Project Number R2008-01980(3)

Conditional Use Permit RCUP200800165 (3)

Subject: Review plans, proposed T-Mobile R.O.W. Antenna Installation Site Number SV11110D, Shoreheights Drive, Sunset Mesa, Los Angeles County, California.

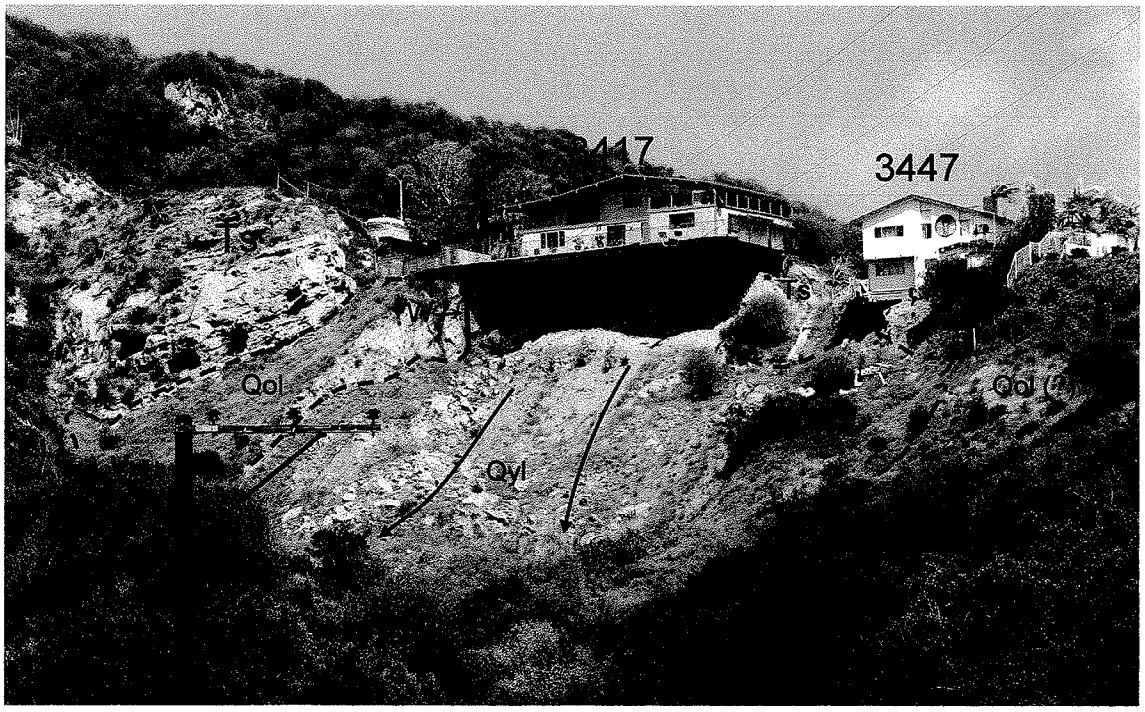
The record indicates that support of the house at 3417 Shoreheights Drive began almost immediately. It involved the installation of two lines of cast-in-place piles. Current conditions at the site are shown in Photo 3.

Photo 4. Shoreheights Drive North of Surfwood Drive Intersection.
Cracks in the pavement suggest movement of a mass to the left of the dotted red line. View is north-northeast. Photo: EDM, 04/01/10.

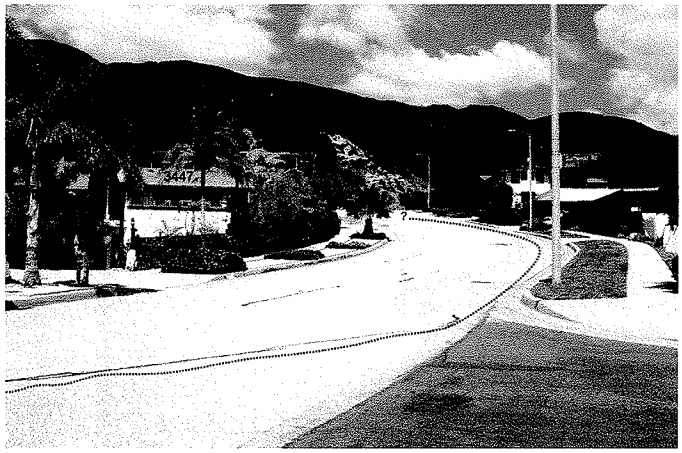
It serves no useful purpose here to discuss details of the March, 1978 landslide and the remedial work related to it in detail. In any event, the record supplied in this regard is incomplete. However, it seems clear that at least incipient movement of the bedrock section from which the slide originally occurred is developing. This seems apparent from the pattern of cracks in asphalt pavement of Shoreheights Drive opposite 3417 - 3459. Photos 4, 5, and 6 show this condition.

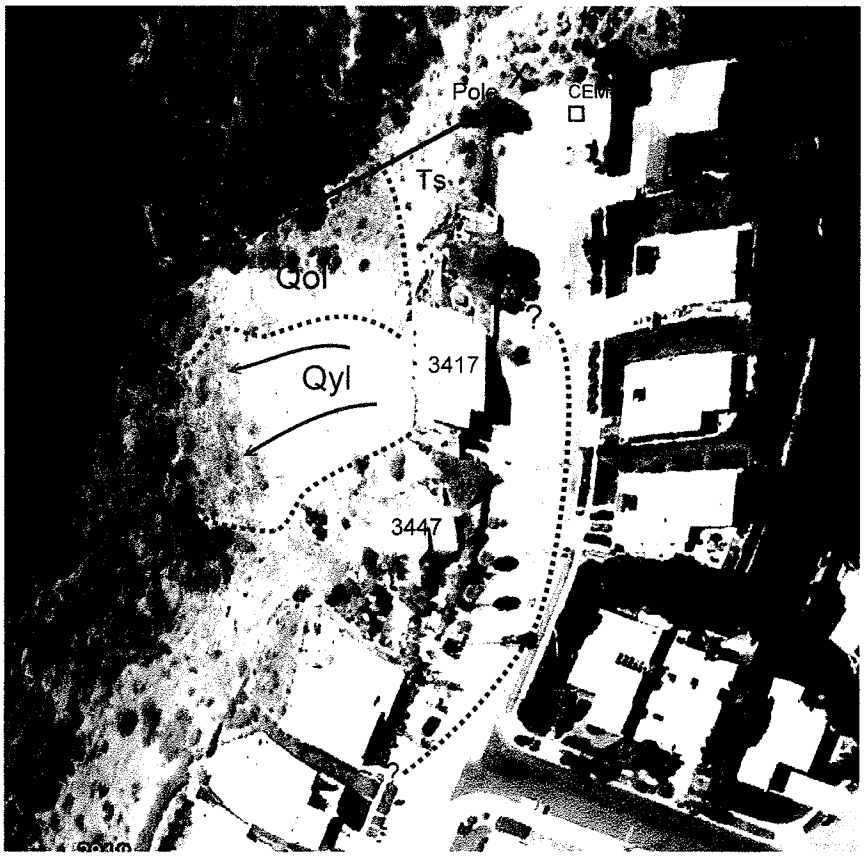
The question of local slope stability is best illustrated by Photo 7.

Figure 1. Section X-X'

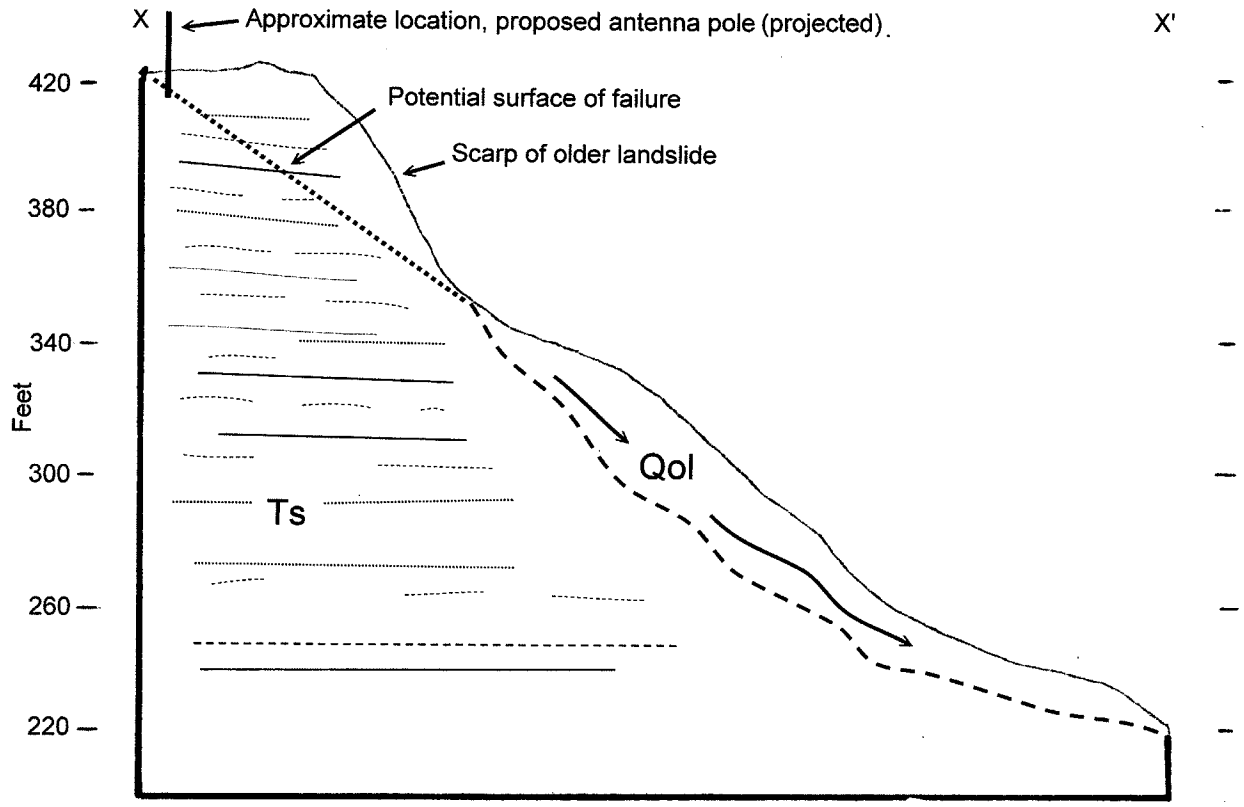
The section above the dotted line in Figure 1 can be analogized to a block on an existing surface with an angle of 35 degrees. The block has an area in the diagram of 1,540 square feet, so assuming a unit weight of 98 pounds per cubic foot from Chamaa's sample at 23-25 feet, the total load, W_t a section of unit width would have on the surface is about 150 kips 1 kip = 1,000 pounds). The driving force, W_d, of the block down the surface would be 123 kips (W_t cos 35). The force normal to the plane, W_n, would be 86 kips (W_t sin 35), and the resisting force, W_r would be the product of the normal force and the coefficient of friction, 0.4, or 35 kips, assuming

zero cohesion from the Chamaa's undisturbed direct shear tests. This resisting force is, of course, much too low, because rocks along the potential surface of failure must have considerable cohesion. In fact, rough calculations indicate that using a friction angle of 22 degrees requires a cohesion of 660 pounds per square foot (psf) for a safety factor of 1.0, and 1,180 psf for a safety factor of 1.5, all quite high, even though the section is taken transverse to the bedding. Such values are due to the relatively low friction angle Chamaa reports.

Even ignoring the possibility of a widening of the existing landslide, if the environmental aspects of the proposed installation concern the safety of the site itself against landsliding, the conditions demand a stability analysis of a section similar to X-X' of Figure 1, and this in turn requires strength data for the Sespe section. In particular, an engineering geology map of the local area with particular attention to relatively weak Sespe siltstone beds observed by down-boring visual logging and the general dip-slope character of the slope are necessary. This approach seems especially appropriate considering the proximity of the Malibu Coast fault with a postulated peak site acceleration of 1.016 g. (*op. cit.*, Seismic Design App., p. 2).
